Project	<b>IEEE 802.16 Broadband Wireless Access Working Group</b> < <a href="http://ieee802.org/16">http://ieee802.org/16</a> >	
Title	<b>Supplemental material for Tgd comments</b>	
Date Submitted	<b>2004-04-24</b>	
Source(s)	Itzik Kitroser Yossi Segal Yigal Leiba Zion Hadad Runcom Technologies Ltd. 2 Hachoma St. 75655 Rishon Lezion, Israel	Voice: +972-3-9528440 Fax: +972-3-9528805 <a href="mailto:itzikk@runcom.co.il">mailto:itzikk@runcom.co.il</a> <a href="mailto:yossis@runcom.co.il">mailto:yossis@runcom.co.il</a> <a href="mailto:yigall@runcom.co.il">mailto:yigall@runcom.co.il</a> <a href="mailto:zionh@runcom.co.il">mailto:zionh@runcom.co.il</a>
Re:	802.16-REVd Sponsor ballot recirc	
Abstract	This document contains supplemental material for 802.16-REVd sponsor ballot	
Purpose	Adopt suggested changes into P802.16-REVd/D4 draft	
Notice	This document has been prepared to assist IEEE 802.16. It is offered as a basis for discussion and is not binding on the contributing individual(s) or organization(s). The material in this document is subject to change in form and content after further study. The contributor(s) reserve(s) the right to add, amend or withdraw material contained herein.

Figure 211—Example of mapping FEC blocks OFDMA slots to subchannels and symbols in the downlink

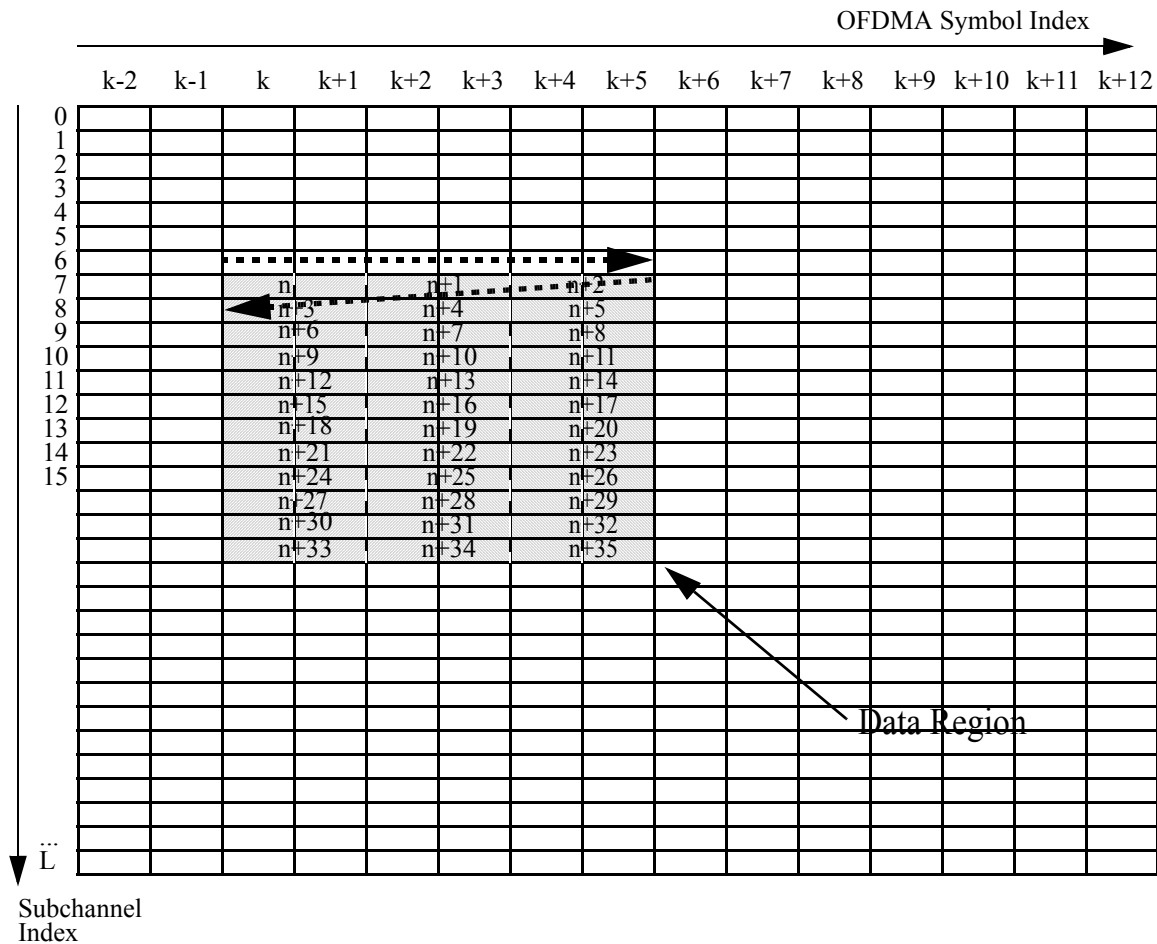
Comment #257. The current OFDMA PHY contain usage of concepts as Zone and a Segment which are not clearly defined anywhere. A clear definition of the terms is required for a consistency reasons. In addition the OFDMA data mapping referes to FEC block, while the correct term is OFDMA slot.

- 1) Segment the data into blocks sized to fit into one ~~FEC block~~OFDMA slot.
- 2) Each ~~FEC block~~ slot shall span one or more subchannels in the subchannel axis and two or three OFDMA symbol in the time axis (see ~~Figure 210 and Figure 211~~). Map the ~~FEC blocks~~ slots such that the lowest numbered ~~FEC block~~ slot occupies the lowest numbered subchannel in the lowest numbered OFDMA symbol.
- 3) Continue the mapping such that the OFDMA symbol index is increased. When the edge of the Data Region is reached, continue the mapping from the lowest numbered OFDMA symbol in the next sub-channel.

Figure 213—Time plan - one TDD time frame (with only mandatory zone)

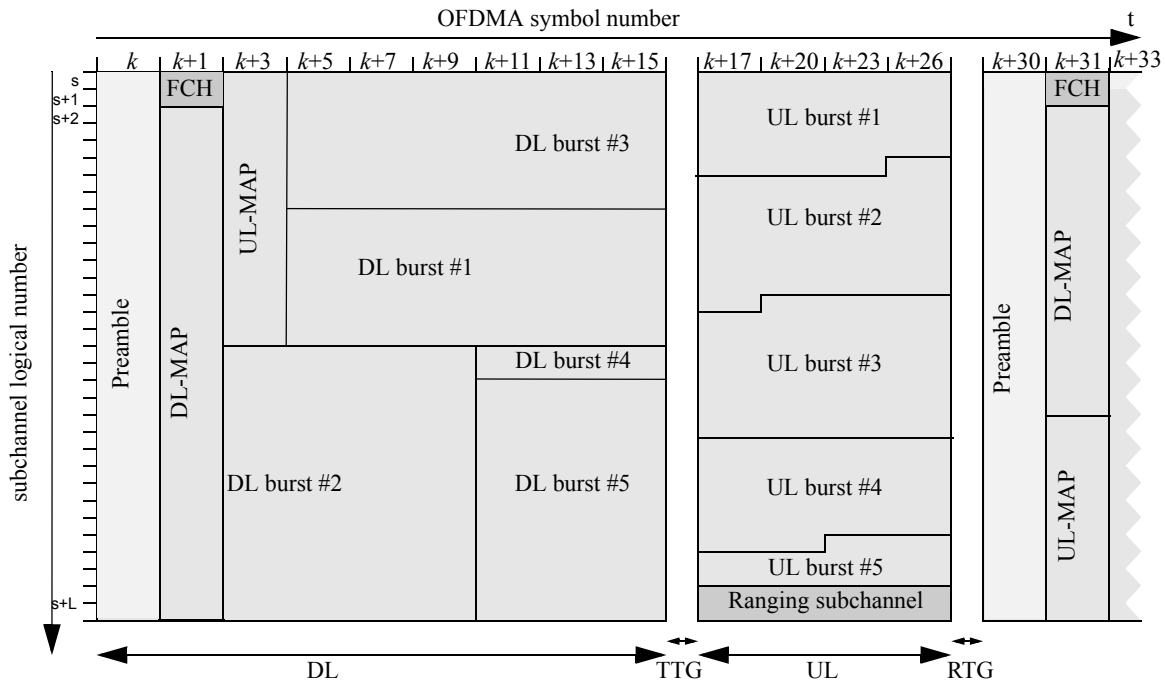
Comment #350 changed the UL allocating scheme to a uni-dimensional scheme. This means that the UL allocations are no longer rectangles, this should be reflected in figure 213. In addition figure 213 does not provide a clear example of the OFDMA frame with multiple zones.

[Page 468, line 5, section 8.4.4.2, change figure 213 (and title) as follows:]

**Figure 215—FCH subchannel allocation for all 3 segments**

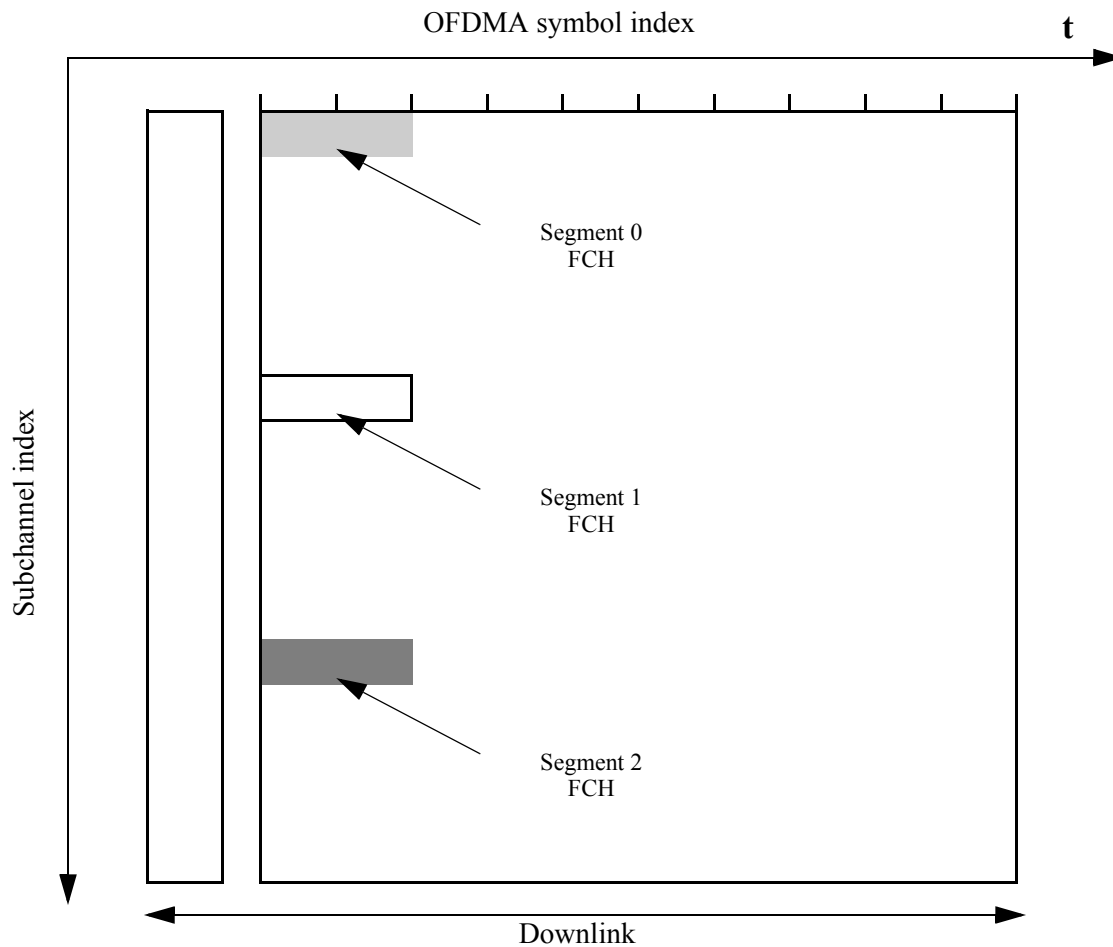
In addition, figure 215 describes the FCH as transmitted over one OFDMA symbol and two subchannels, and should be two OFDMA symbols over one subchannel.

**[Page 471, line 4, section 8.4.4.5, replace figure 215 with the following figure]**

Figure 216—Example of renumbering the allocated subchannels for segment 1 in PUSC

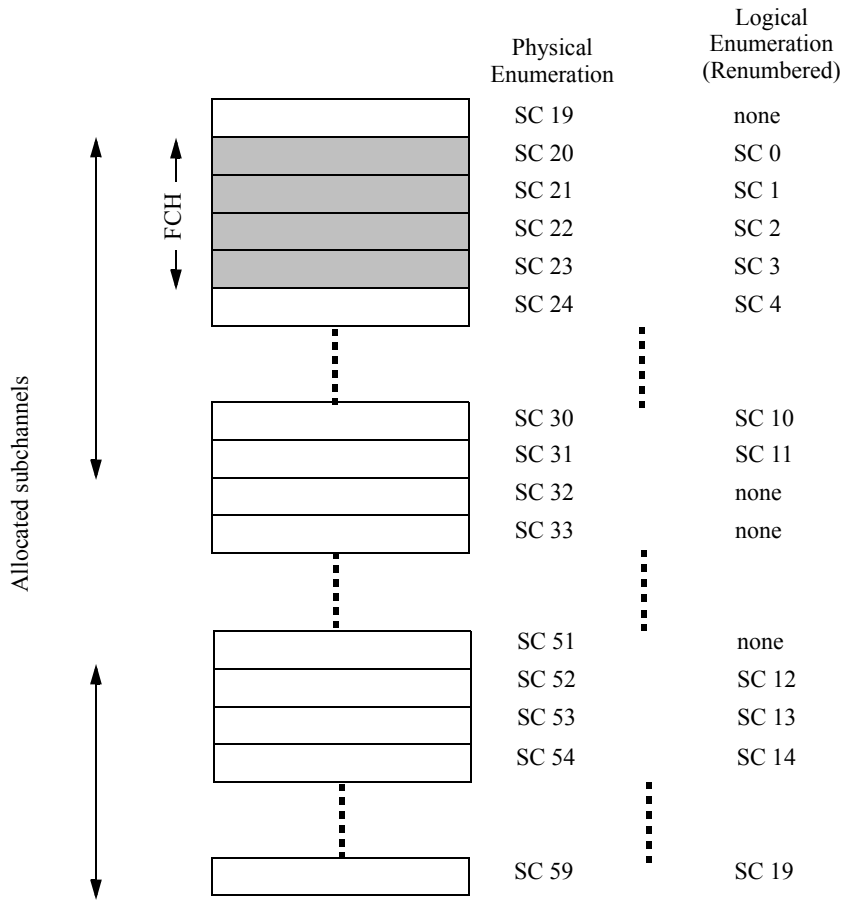
The example given in figure 216 is wrong, since the standard defines that the FCH is transmitted using a duration of 4 OFDMA subchannels.

**[Page 472, line 2, section 8.4.4.5, Change figure 216]**

Figure 217—Example of UL renumbering the allocated subchannels for a segment in PUSC

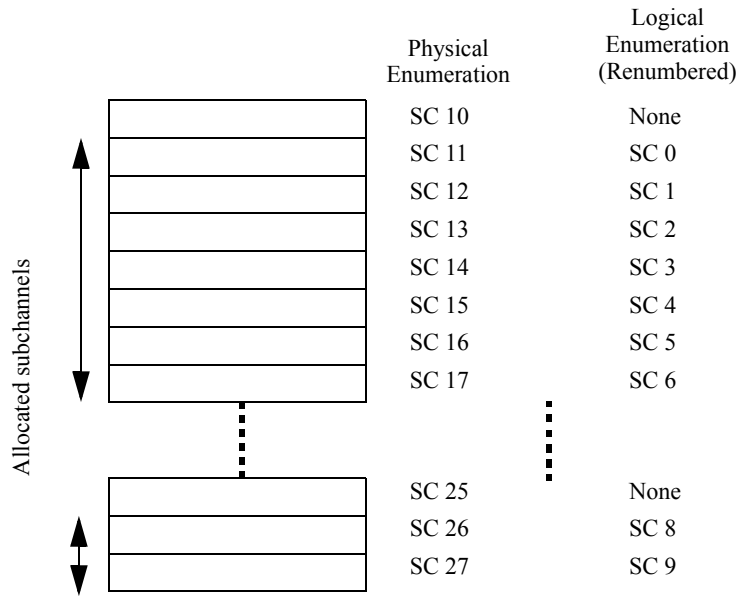
The current subchannels renumbering definition for the UL stating that "no renumeration is done" is wrong, since obviously a renumbering scheme is required.

[Page 472, line 2, section 8.4.4.5, Insert new figure 217]

Figure 235— STC usage with OFDMA for FUSC

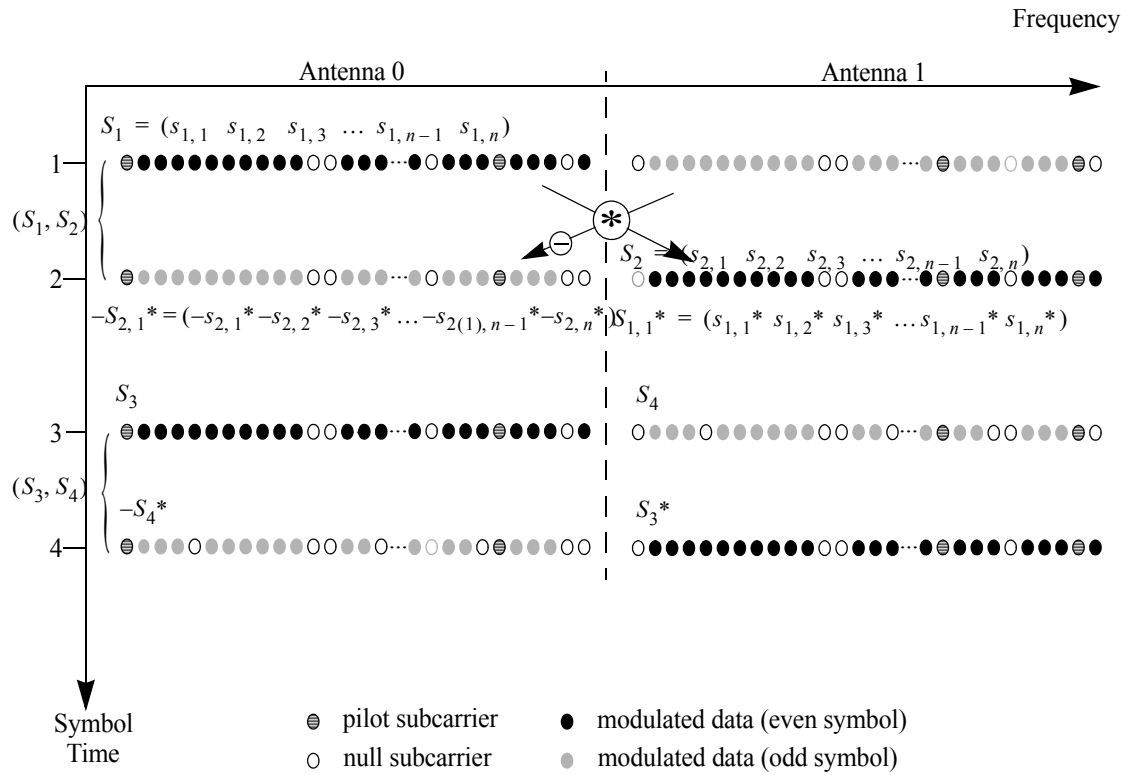
Comment #362 contained instruction to change figure 235, this comment wasn't implemented due to an unclear instruction, this comment provide the required changes. In addition, the existing figure is relevant for FUSC only, an additional figure is required for the PUSC case.

[Page 519, line 3, section 8.4.8.2.1, change figure 235 as indicated, change title to make figure relevant to FUSC]
